Standard Authorization Request (SAR)

Requested information			
SAR Title:	PRC-002-2 Disturbance Monitoring and Reporting Requirements		
Date Submitted:	April 8, 2021		
SAR Requester			
Name:	Terry Volkman		
Organization:	Glencoe Light and Power NCR11444		
Telephone:	612-419-0672	Email:	terryvolkman@gmail.com
SAR Type (Check as many as apply)			
<input type="checkbox"/> New Standard <input checked="" type="checkbox"/> Revision to Existing Standard <input type="checkbox"/> Add, Modify or Retire a Glossary Term <input type="checkbox"/> Withdraw/retire an Existing Standard		<input type="checkbox"/> Imminent Action/ Confidential Issue (SPM Section 10) <input type="checkbox"/> Variance development or revision <input type="checkbox"/> Other (Please specify)	
Justification for this proposed standard development project (Check all that apply to help NERC prioritize development)			
<input type="checkbox"/> Regulatory Initiation <input type="checkbox"/> Emerging Risk (Reliability Issues Steering Committee) Identified <input type="checkbox"/> Reliability Standard Development Plan		<input type="checkbox"/> NERC Standing Committee Identified <input type="checkbox"/> Enhanced Periodic Review Init

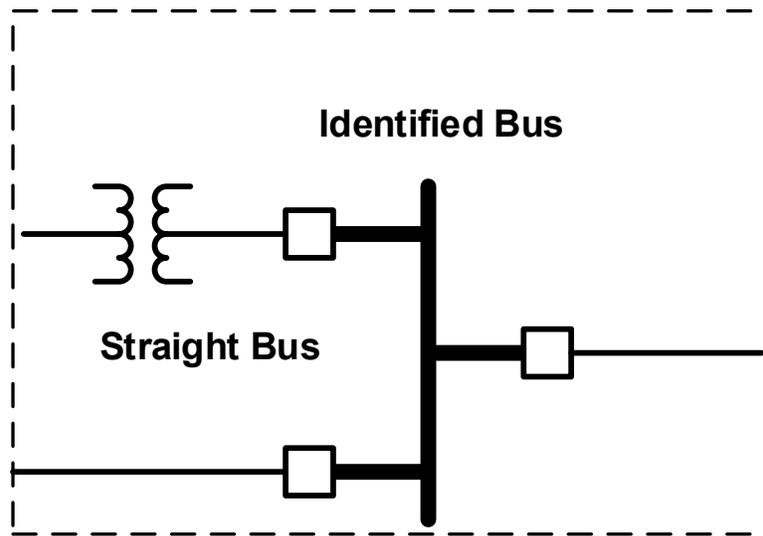
The above figure of a straight bus is the simplest BES bus configuration contained within a common ground grid. Only the BES circuit breakers are connected to the identified BES bus. In this case it is clear concerning SER data in Requirement R2 because the circuit breaker is “directly connected.”

However, to achieve the need for FR data in Requirement R3, the identified BES bus owner notifies the transformer and transmission line owners under Requirement R, Part 1.2 thus obligating them to have FR data where the circuit breaker is directly connected and the logical BES Element to record FR data.

Under the current Requirement R3, the notified GO or TO transformer or line owner will need to contact the circuit breaker owner in hope of obtaining FR Data or install their own equipment. The GO or TO cannot compel the circuit breaker owner to have FR data. Additionally, relying on another entity that has no reliability responsibility for complying with PRC-002-2 places the transformer or transmission line owner at risk if the other entity fails to have the necessary and adequate FR data. The intent of the standard in Requirement R3 is to have FR data associated with all applicable BES Elements at a single BES bus that includes physical buses with breakers connected at the same voltage level within the same physical location sharing a common ground grid of the identified BES bus. Requirement R1, Part 1.2 should only require notification to the BES Element (i.e., circuit breaker) owner directly connected with the identified BES bus.

Requirement R1, Part 1.1 uses a method and BES bus definition⁴ outlined in Attachment 1 to identify BES buses that require SER data and/or FR data. Part 1.2 requires the notification of other BES Element owners connected to the identified BES bus under Requirement R1, Part 1.1. As currently written, a notification is required regardless of whether the identified BES bus owner has FR data for the intended BES Element (i.e., transformer or transmission line) or owns the BES Elements directly connected to the identified BES bus. Requirement R1, Part 1.2 should be modified such that only the directly connected BES Element owner to the identified BES bus at the same voltage level within the same physical location sharing a common ground grid of the identified BES bus shall have FR data.
